UNITED STATES PATENT AND TRADEMARK OFFICE

APPLICATION NO.	FILING DATE	FIRST NAMED INVENTOR	ATTORNEY DOCKET NO.	CONFIRMATION NO.
10/538,176	06/09/2005	Chikamasa Yama	04676.0184-00000	1747
22852	7590	04/09/2007	EXAMINER	
FINNEGAN, HENDERSON, FARABOW, GARRETT & DUNNER LLP 901 NEW YORK AVENUE, NW WASHINGTON, DC 20001-4413			ALI, SHUMAYA B	
			ART UNIT	PAPER NUMBER
			3771	
SHORTENED STATUTORY PERIOD OF RESPONSE		MAIL DATE	DELIVERY MODE	
3 MONTHS		04/09/2007	PAPER

Office Action Summary

DETAILED ACTION

Prior Art
Fig. 2A
US 6,039,042

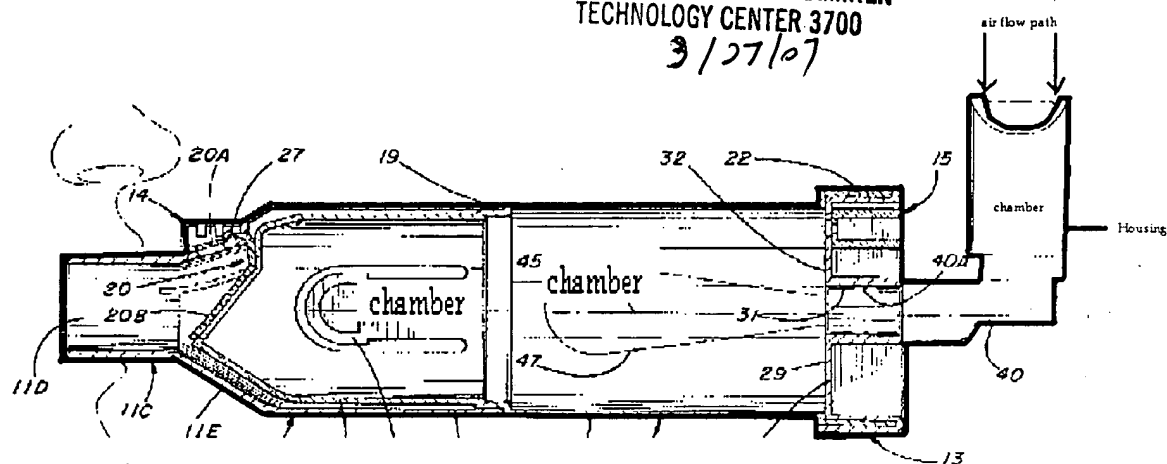
As to claim 1, Sladek in figures 1-8 discloses an inhalation device for transpulmonary administration a chamber (space inside the apparatus depicted in fig.2A, see labeled fig.2A attached below) for containing a pharmaceutical composition which is pulverized into fine particles by an air-generated impact for dispersal in air; an air inlet flow path (see labeled fig.2A, attached below) for introducing to the chamber outside air to apply the air-generated impact to the pharmaceutical composition and for injecting the outside air toward the pharmaceutical composition; an inhalation flow path (31) having a suction port (a path through apertures formed by ribs 29, see fig.1) located inside the chamber to inhale the pulverized pharmaceutical composition; a housing (body of the apparatus depicted in fig.2A, see labeled fig.2A attached below) for accommodating the chamber, the air inlet flow path, and the inhalation flow path; a mouthpiece (11) provided at one end of the housing, the mouthpiece being provided with a mouth-side flow path (11D) which communicates with the inhalation flow path, and an auxiliary

flow path (20A) for directly inhaling the outside air which does not communicate with the inhalation flow path and the mouth-side flow path. Sladek, however, lacks explicit teachings of wherein the inhalation device for transpulmonary administration is configured such that the air-generated impact is applied to the pharmaceutical composition by the outside air which flows into the chamber by inhalation-induced pressure generated when a user (patient) inhales air, and the pulverized pharmaceutical composition is introduced to the mouth-side flow path, and at the same time the outside air is directly introduced to the auxiliary flow path by the inhalation-induced pressure. However, it should be noted that the “air-generated impact” and “pulverized pharmaceutical composition” are provided by the air flow port/paths as claimed, and such air flow port/paths are taught by Sladek, thus, Sladek’s device is inherently capable of providing air-generated impact and pulverization of the pharmaceutical composition. Therefore, it would have been obvious to one of ordinary skill in the art to consider the use of Sladek’s device would have provided the function of “air generated impact” and pulverization of the pharmaceutical composition because Sladek also teaches a housing large enough to provide a pulverization surface (see fig.2A) for the pharmaceutical to be impacted when the outside air is introduced into the housing by the inlet flow path, auxiliary flow path, and/or suction port prior to inhalation.
